HILLPOINTE APARTMENTS AT PETERSON
CONSTRUCTION DRAWINGS - STORM SEWER PLAN & PROFILES

HILLPOINTE APARTMENTS AT PETERSON
HILLPOINTE, LLC.
COLORADO SPRINGS, EL PASO COUNTY, COLORADO

CONSTRUCTION DRAWINGS
STORM COVER & NOTES

PCD FILE NO.: PPR2613

CONSTRUCTION DRAWINGS
STORM PLAN & PROFILE I

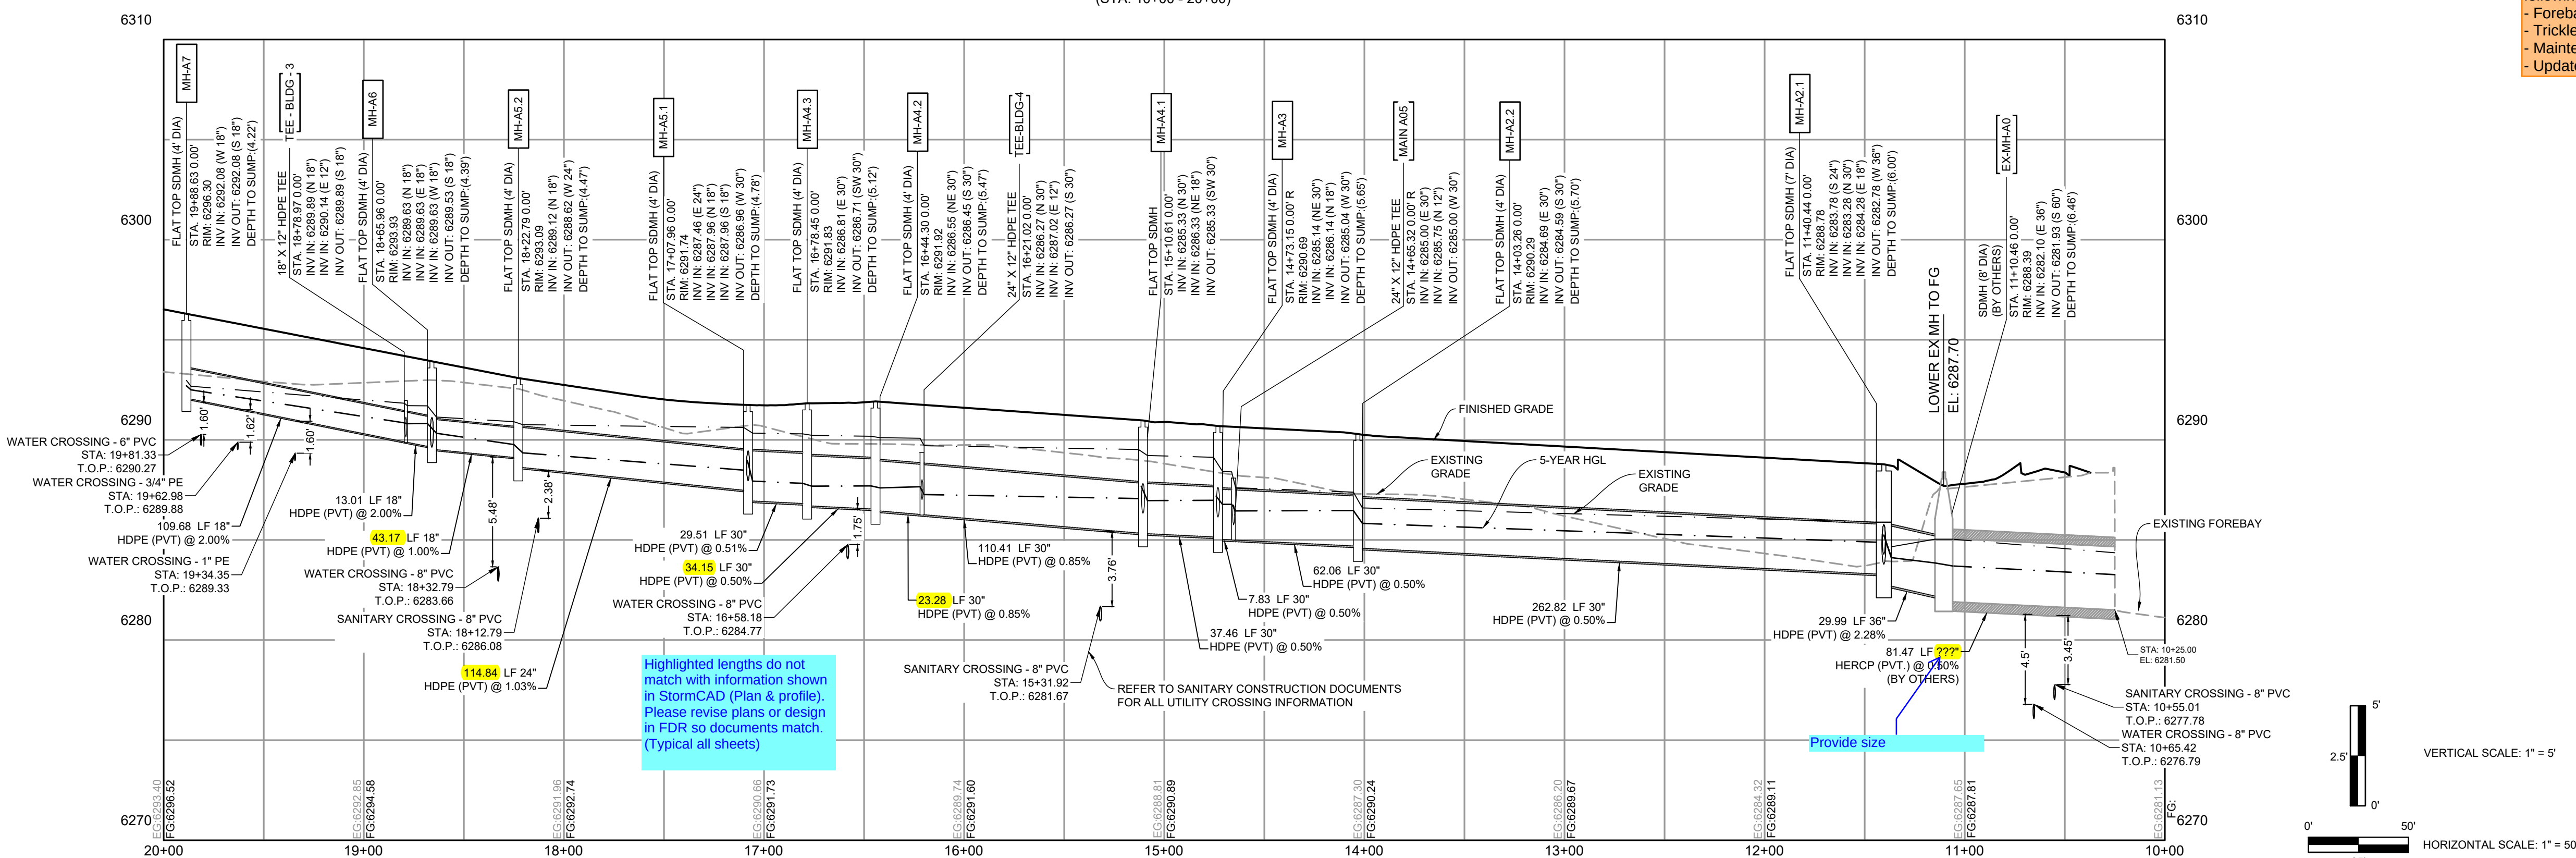
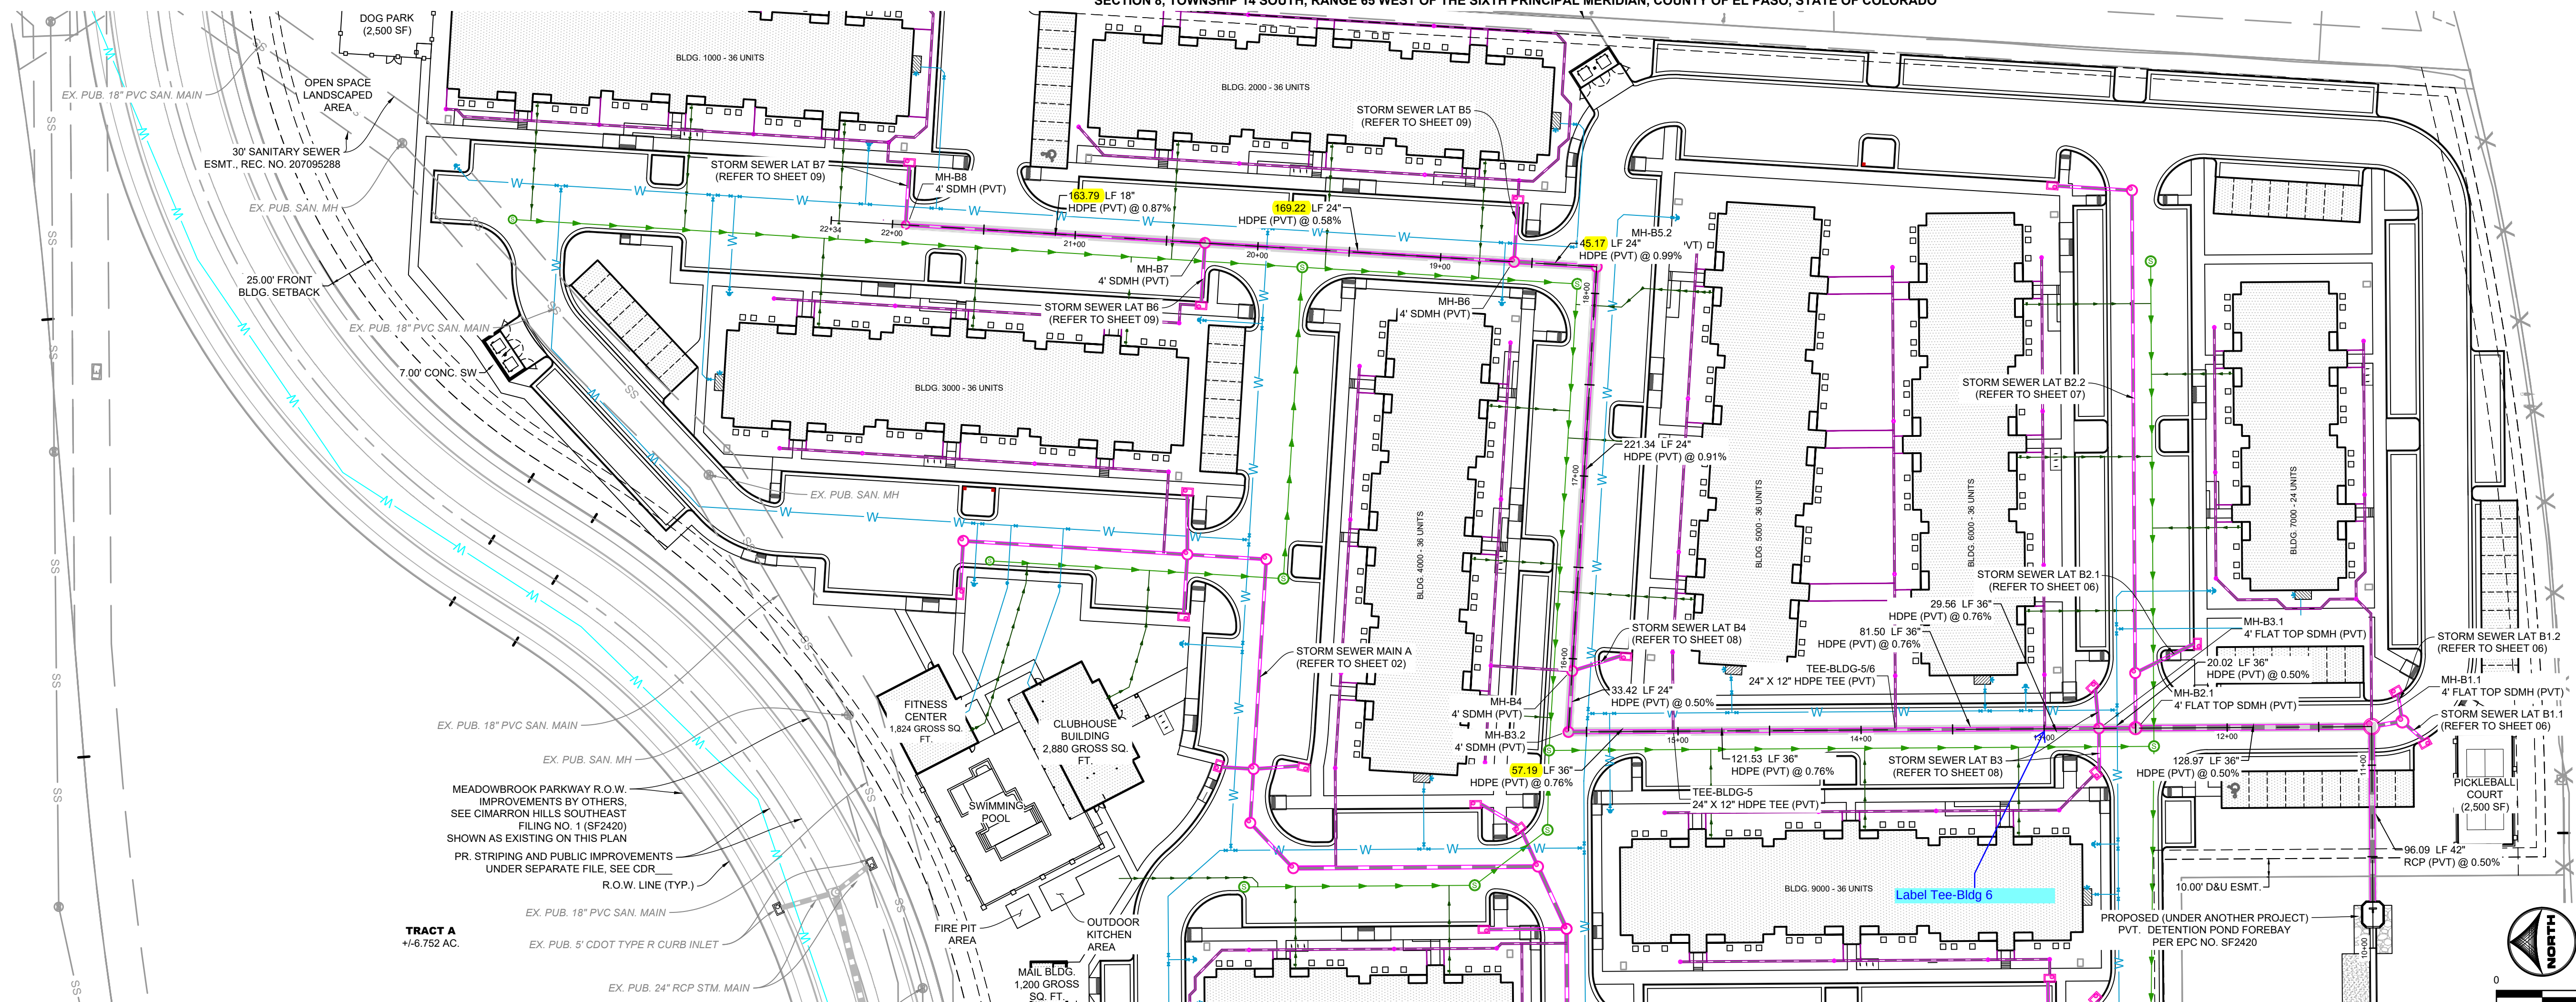
Add note that for any storm pipe where HGL is outside of the pipe, water tight seals will be required.

Provide designs for the following:
- Forebay
- Trickle channel
- Maintenance access path
- Updated office plate
